REVIEW OF ALBA GALLEGO'S LAB1

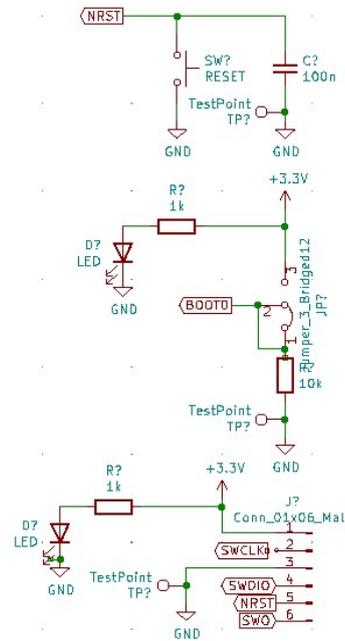
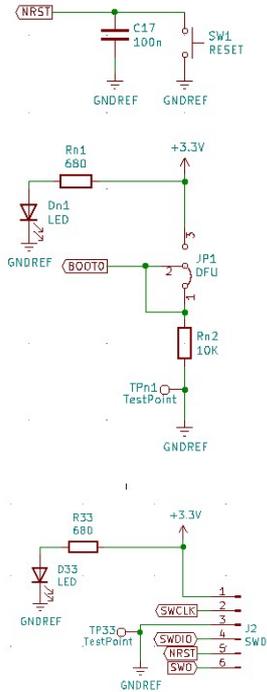
In this part of the design, we can see that the value of the resistors in front of the LED are different. However, in the rest of the design he has written the same value that I decided to write, so it was probably just an oversight.

In the NRST block I have put one more testpoint, I think it would be useful to corroborate properly and more easily the correct functioning of the design.

Also, here the order in which we have set the reset and the condenser is different. Considering that the capacitor is for noise filtering, it would make more sense the way it is placed.

Alba has also placed several test points at different inputs and outputs of the MCU. A good way to be able to follow the proper functioning of the system.
